ADDENDUM TO THE CONTRACT

Gastineau Elementary School Renovation

Contract No. E11-137

ADDENDUM NO.: TWO

A2.4

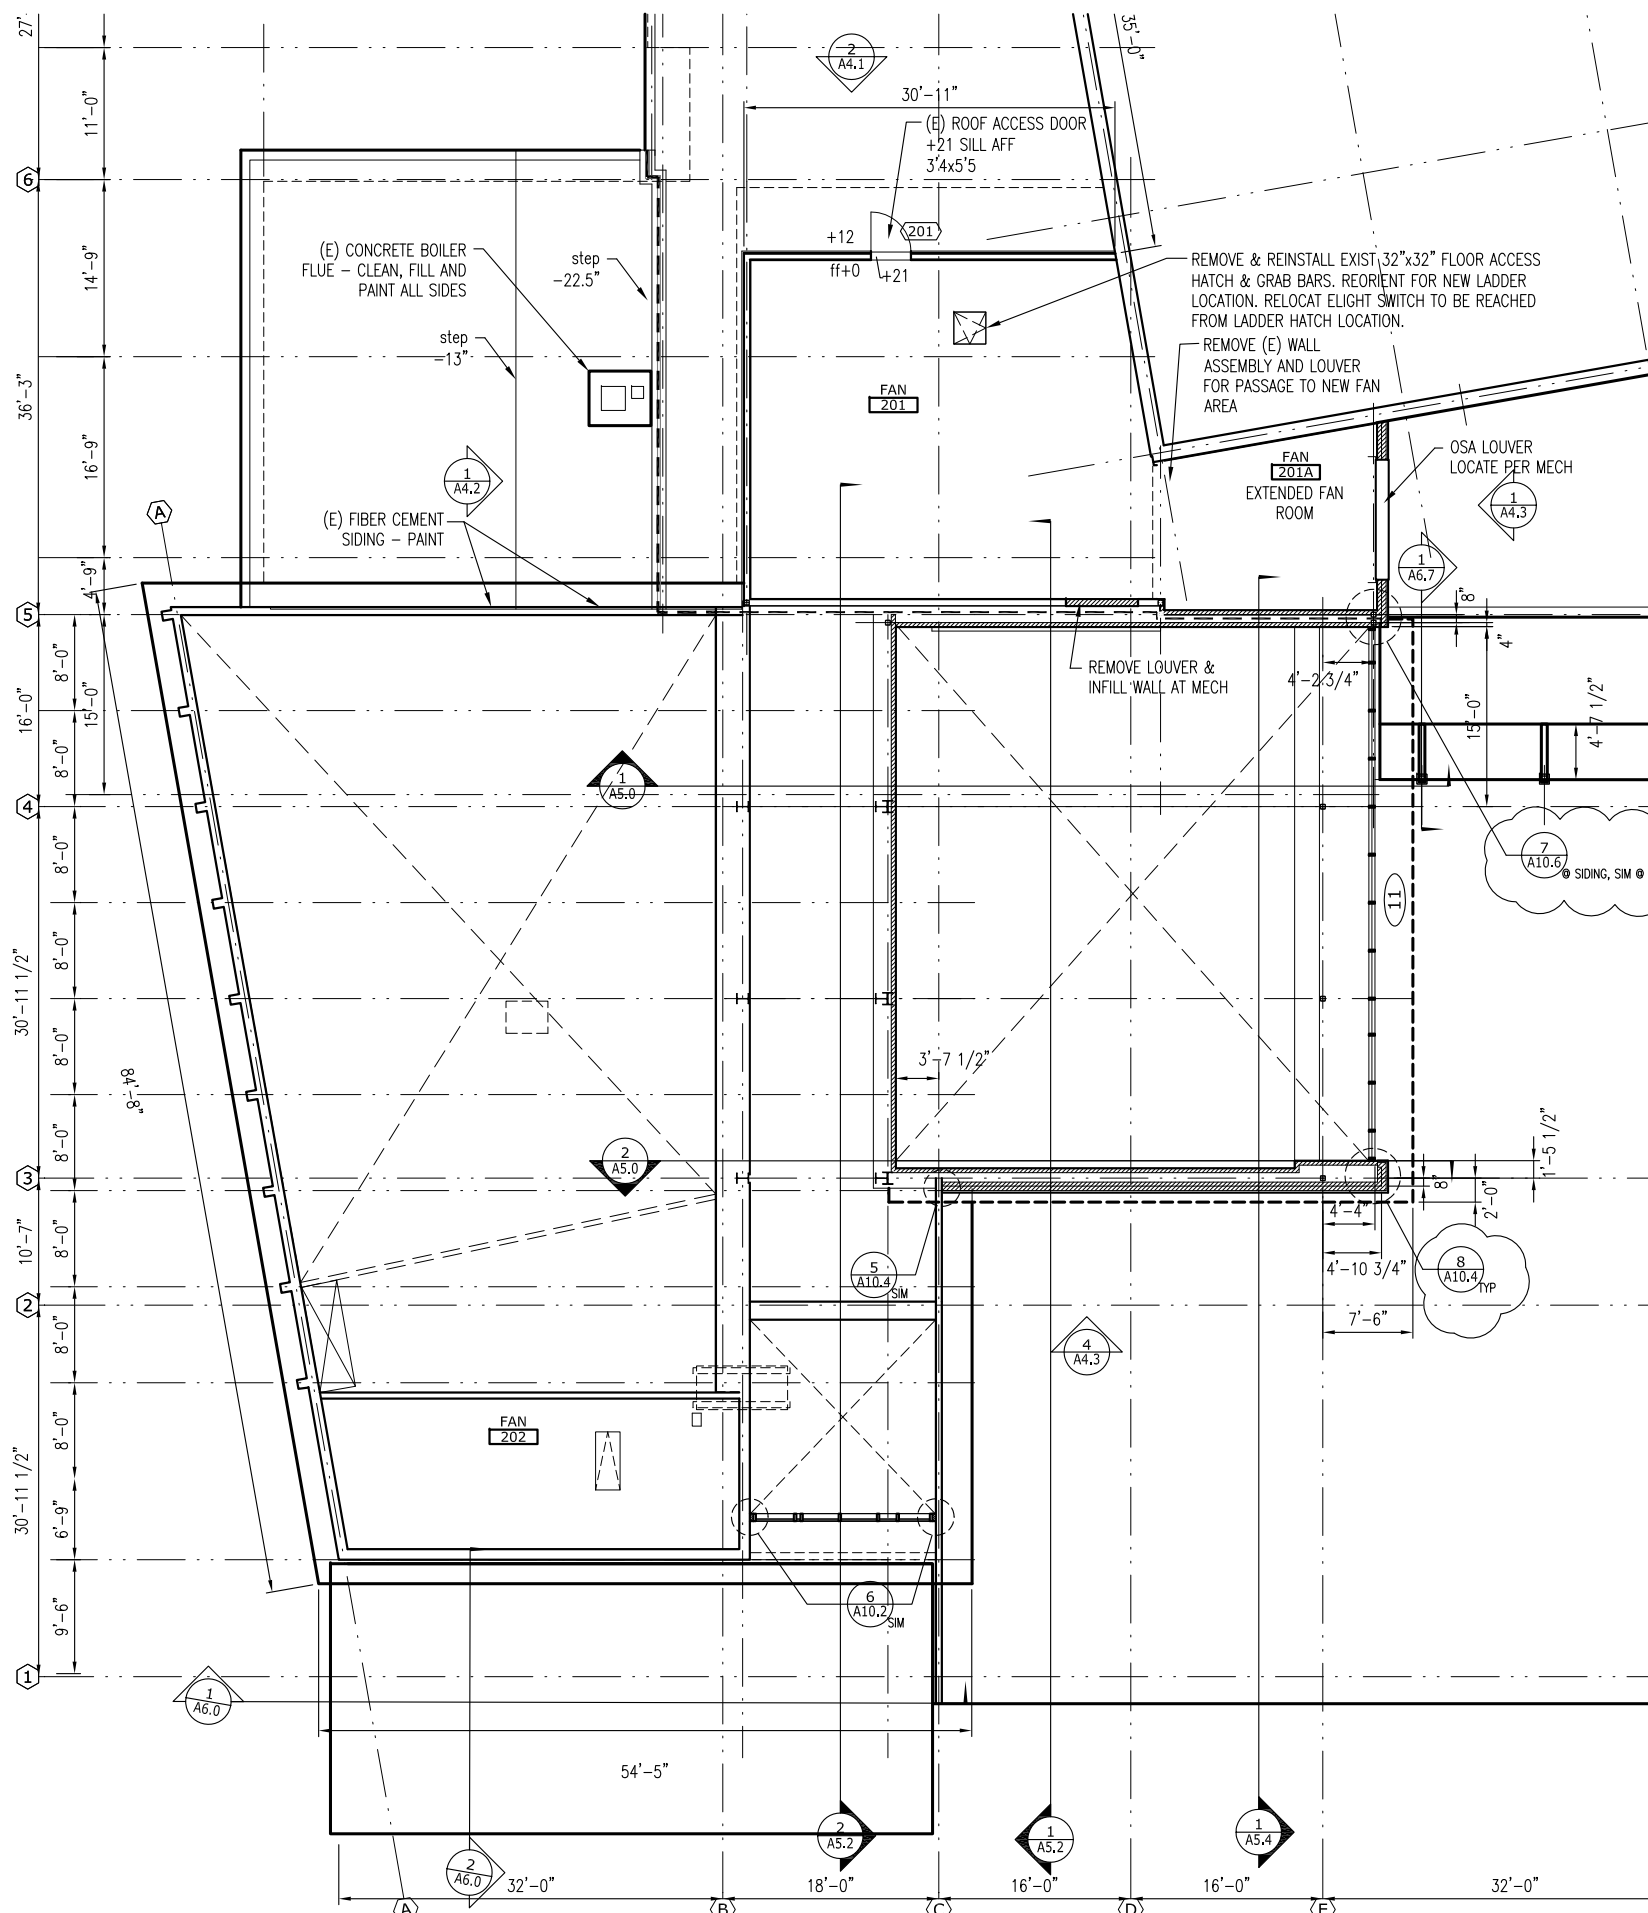
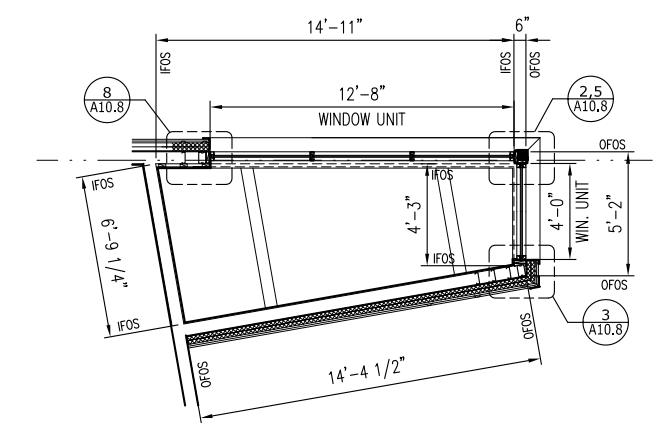
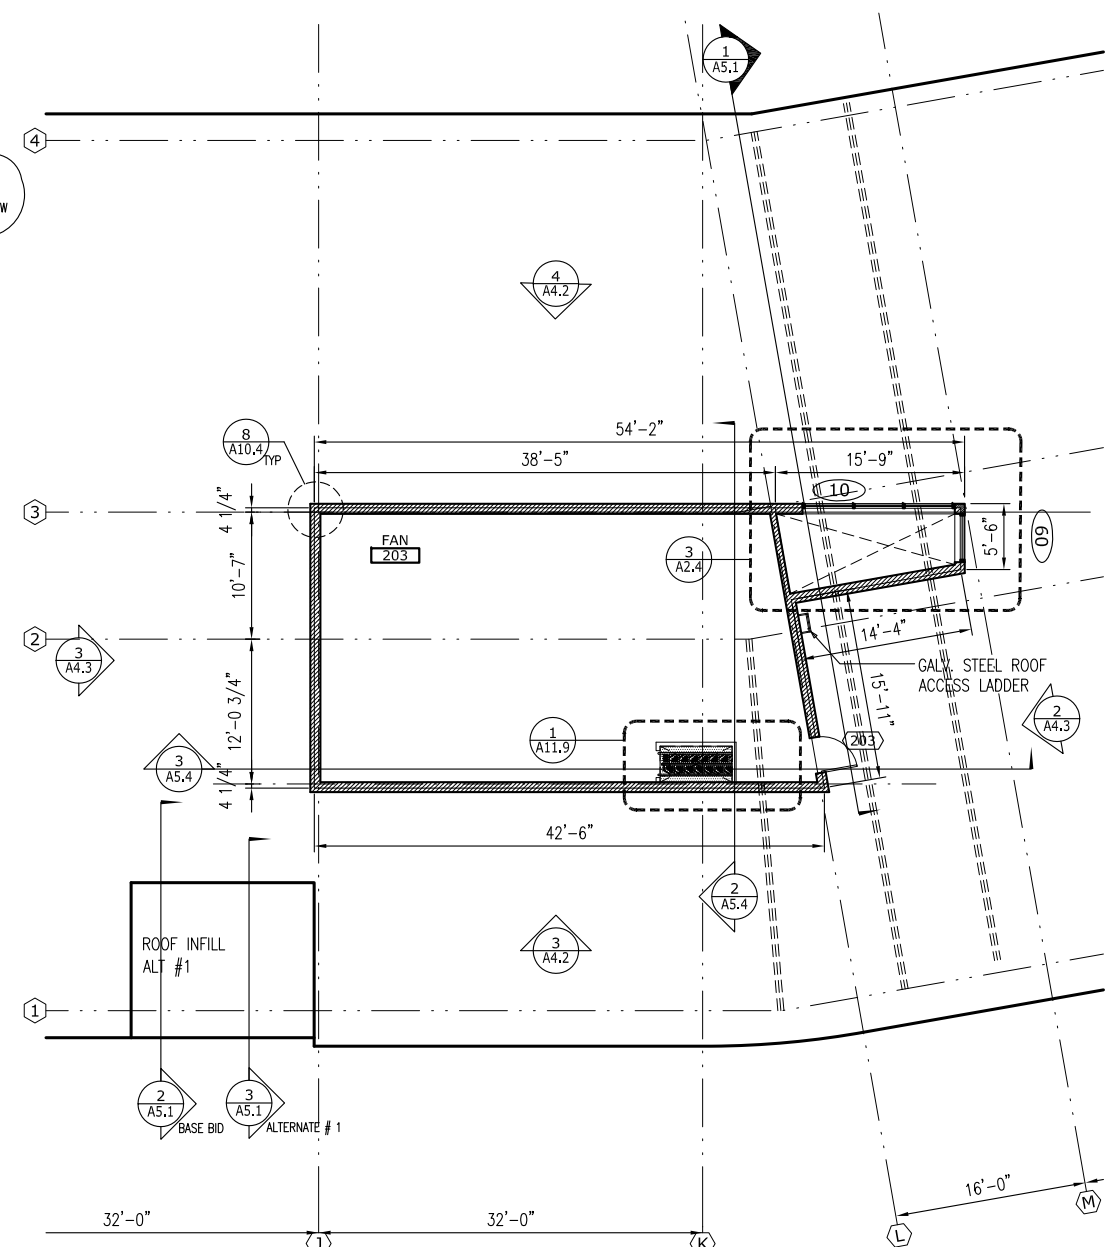
- Item No. 23 A2.4: Delete Sheet A2.4 and replace with attached sheet A2.4. Modifications relate detail flag reference changes in two locations. Line-work clarity is improved for half-size drawings.

SHEET #
A2.7
Addendum No. 2

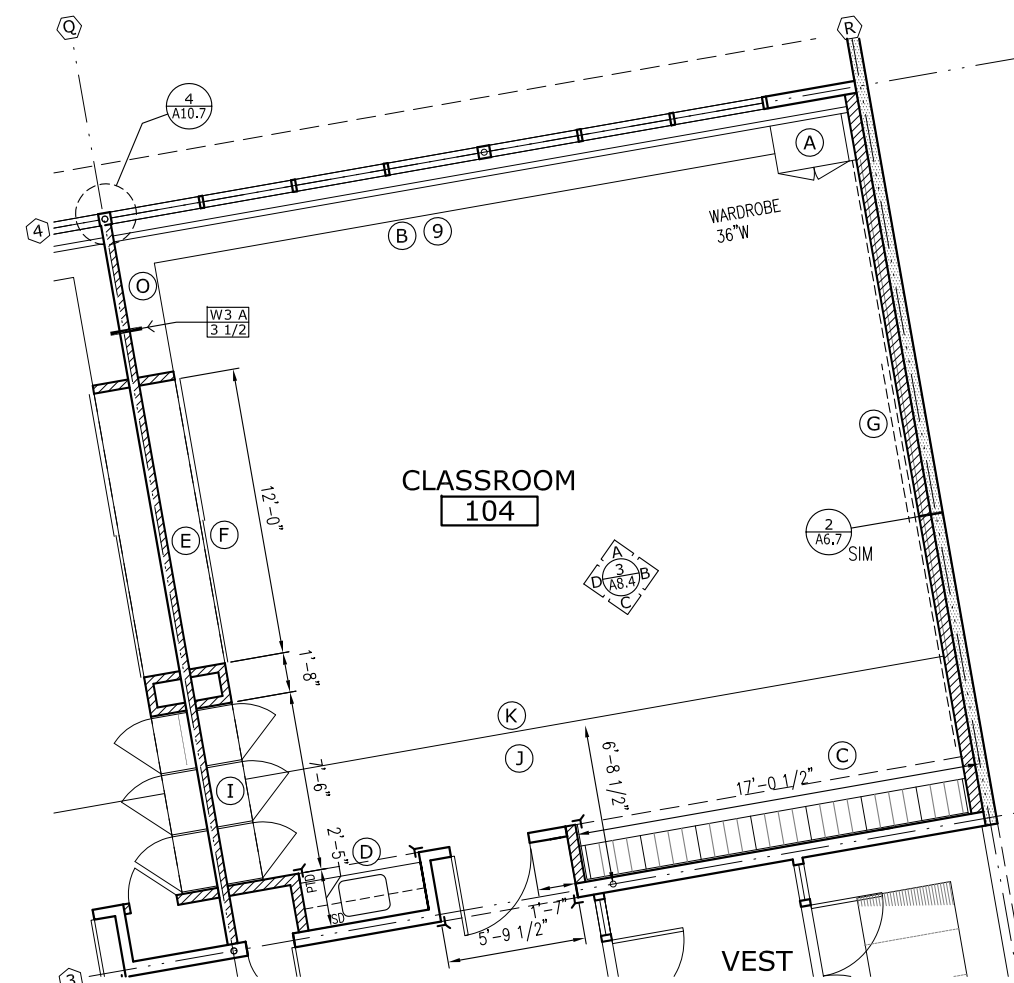
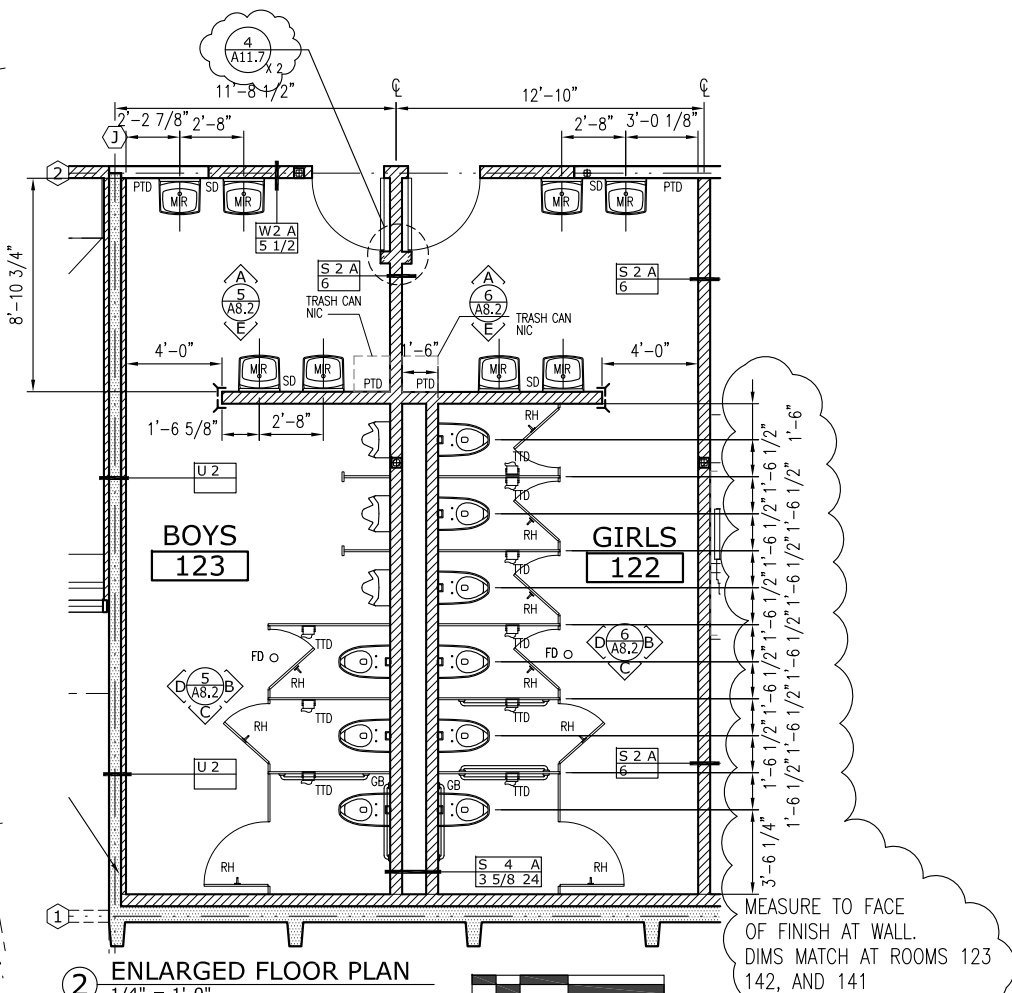
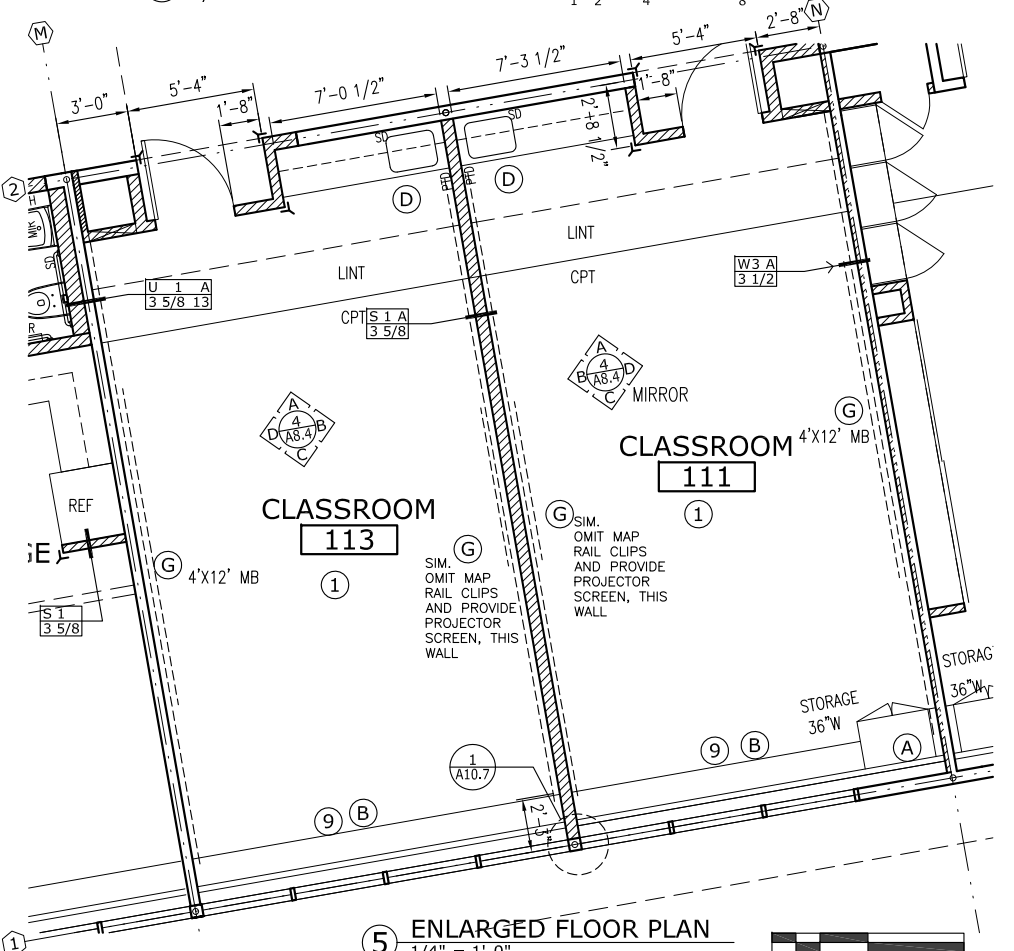
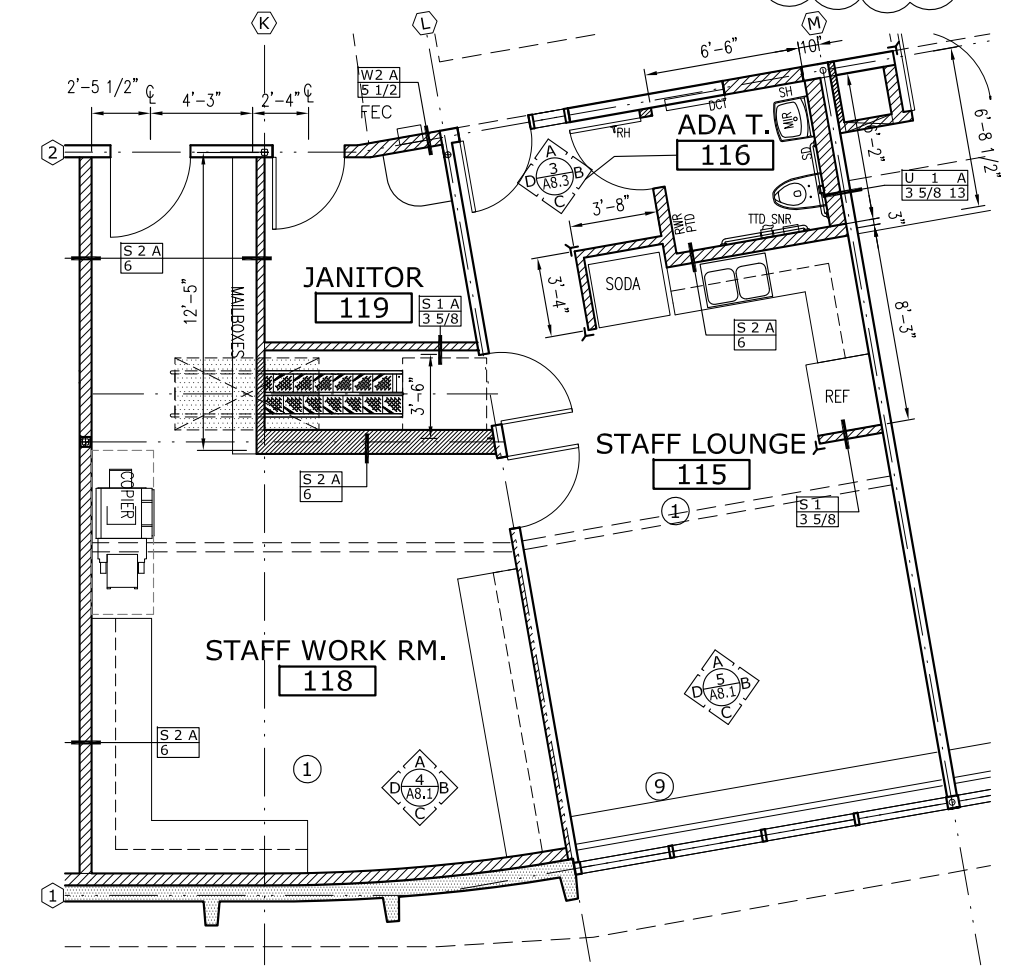
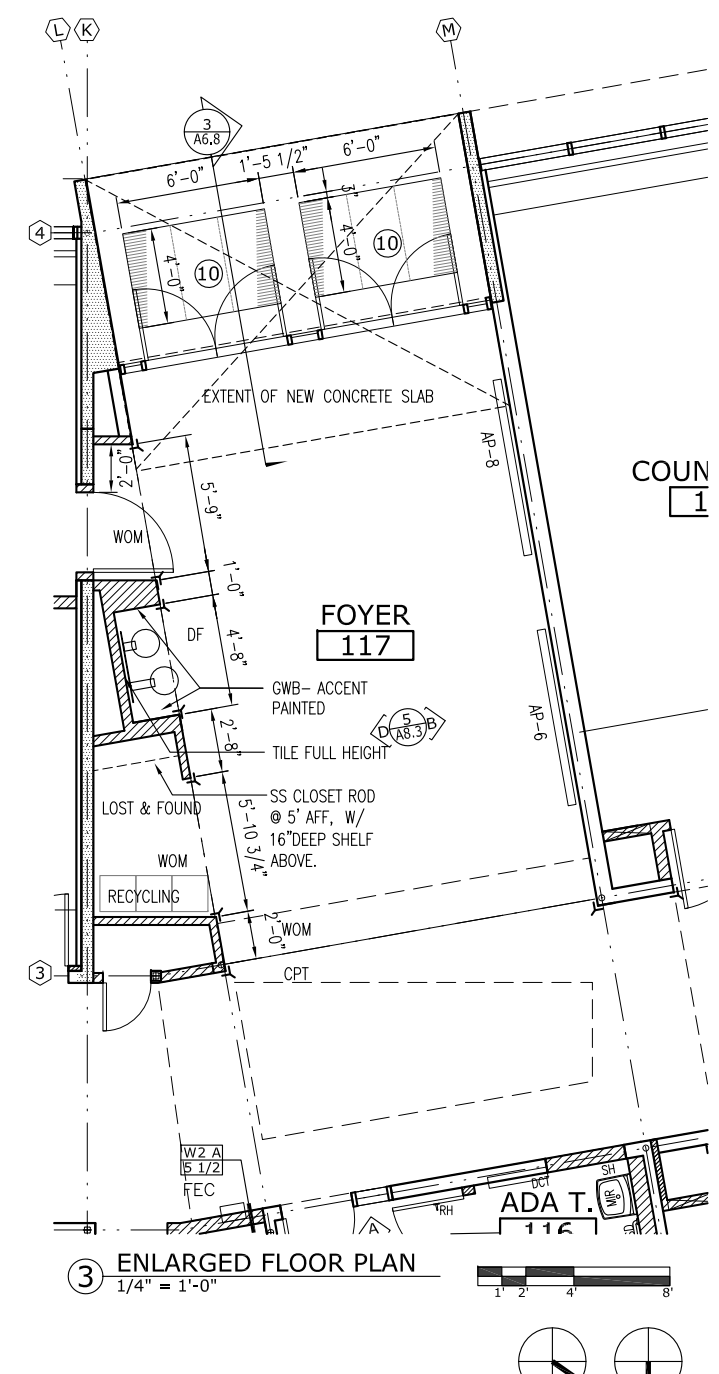
- Item No. 24 A2.7: Delete Sheet A2.7 and replace with attached sheet A2.7. Modifications relate detail flag reference changes in one location, and inclusion of dimension string at 2/A2.7.

SHEET A10.2
ASK-1

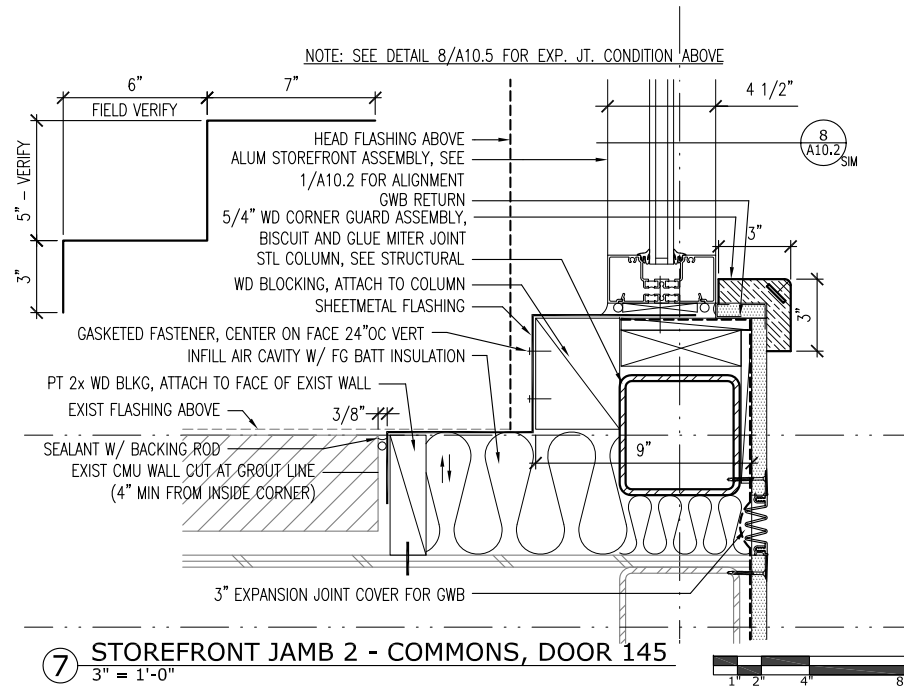
- Item No. 42 /A10.2: Delete detail 7/A10.2 and replace with detail 7/A10.2 provided as ASK-1.
- Item No. 43 7/A10.6: Delete detail 7/A10.6 and replace with detail 7/A10.6 provided as ASK-2.
